RE: Bernheim Middle School - BG 23-051 - Change Order 37 – Front Entrance
Modifications **DC**

PROJECT: *(Name and address)*
Bernheim Middle School Renovation
700 Audubon Drive, Shepherdsville, KY
40165

CHANGE ORDER INFORMATION:
Change Order Number: 37
Date: 08-25-2025

Change Order Request 57 - PCO #178 - RFP 31-A & 31-B Front Entry Concrete & Canopy

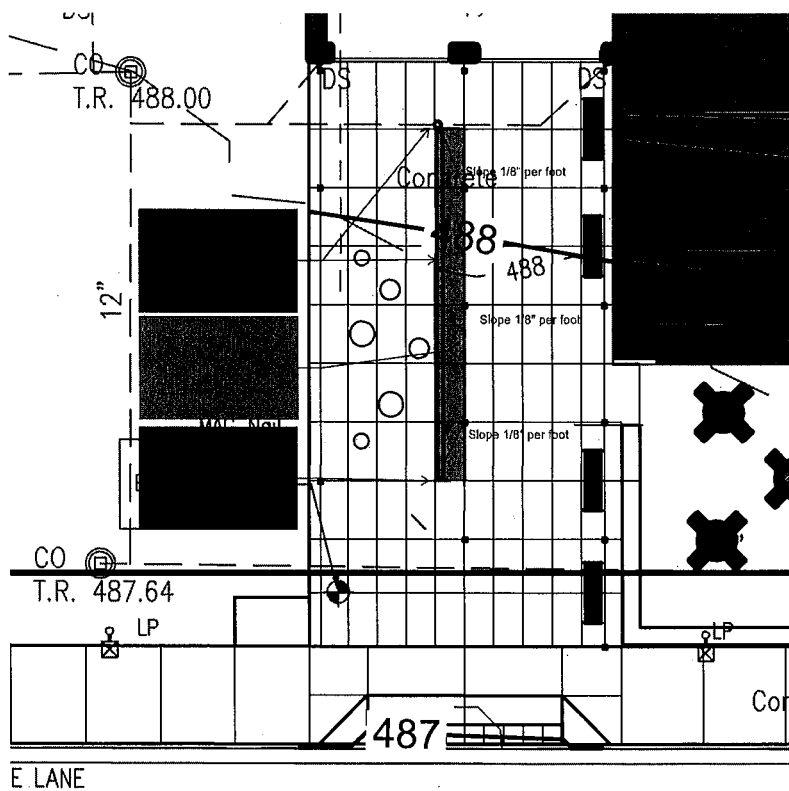
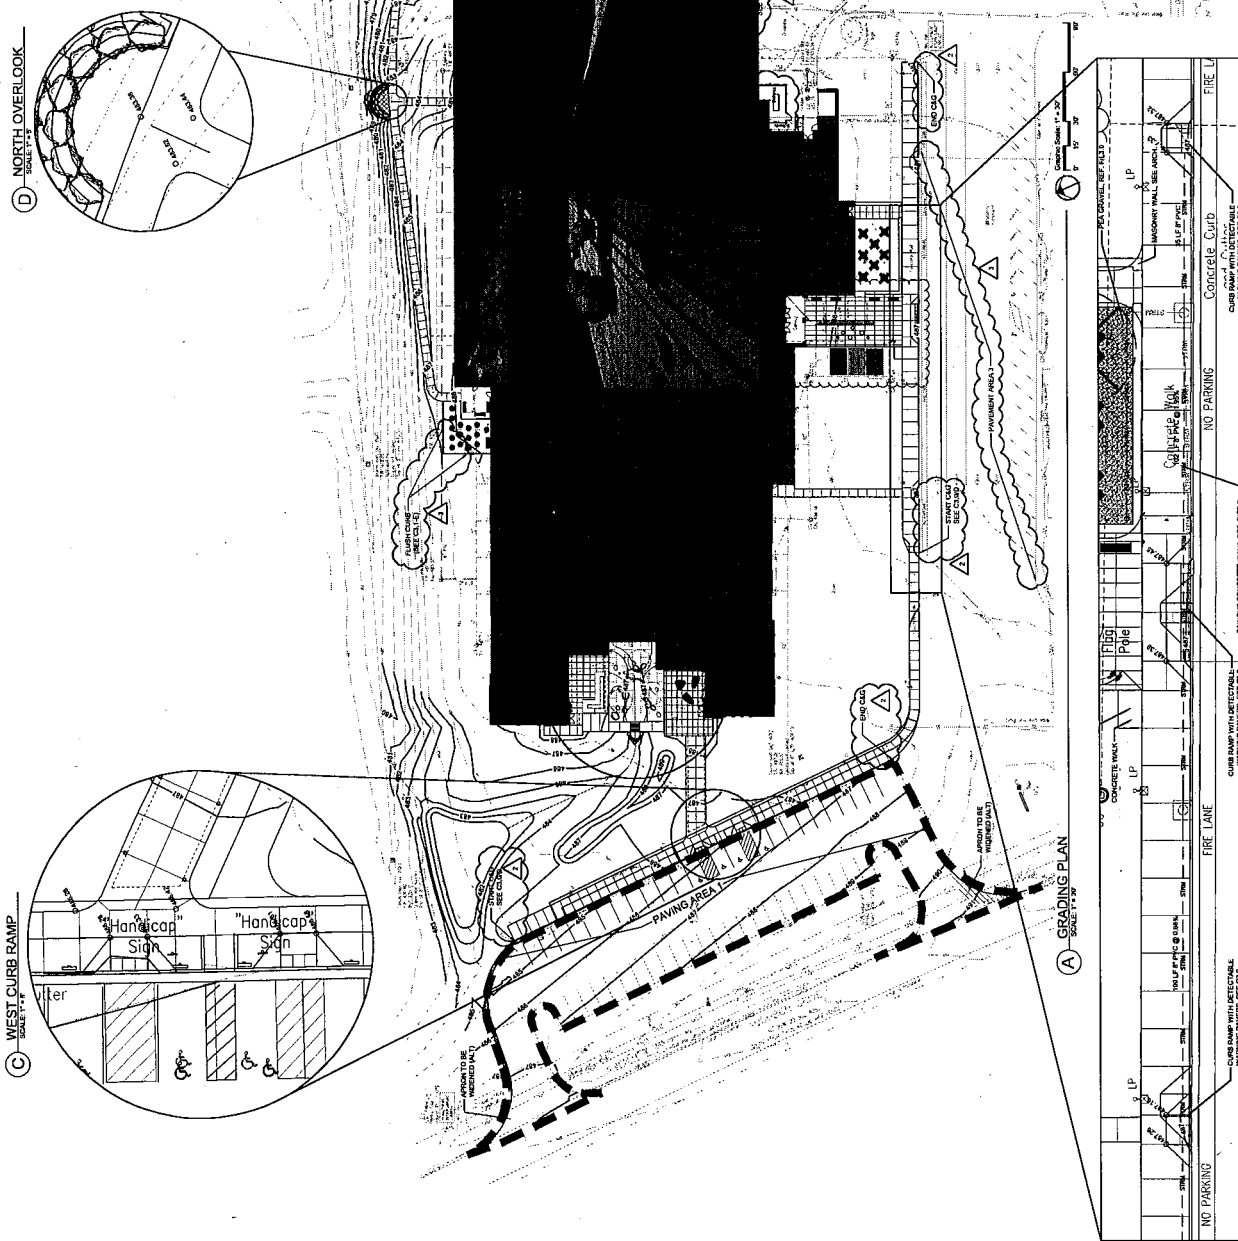
Item No. 1 Refer to Mark Up below: Civil Revisions:

- Provide Trench Drain and connection to existing storm system.
- Replace concrete paving at trench drain and at storm connections.

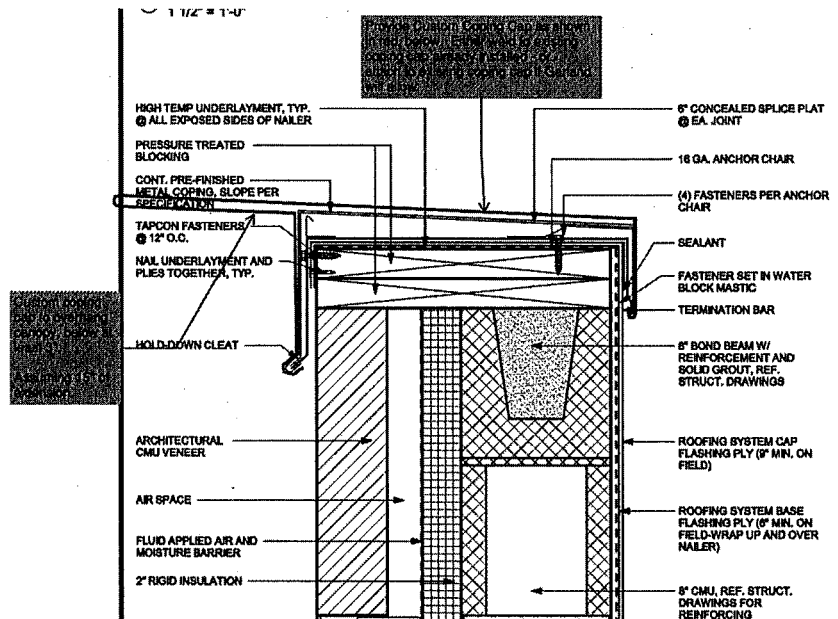
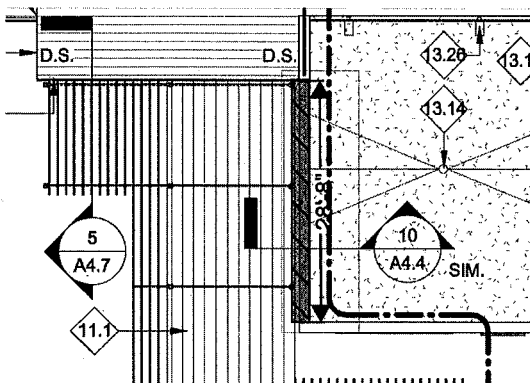
Item No. 1 Refer to Mark Up below: Architectural Revisions:

- Provide 28' - 8" of 22 gauge Break Metal coping attached to parapet as shown in detail below to bridge opening between building and canopy.
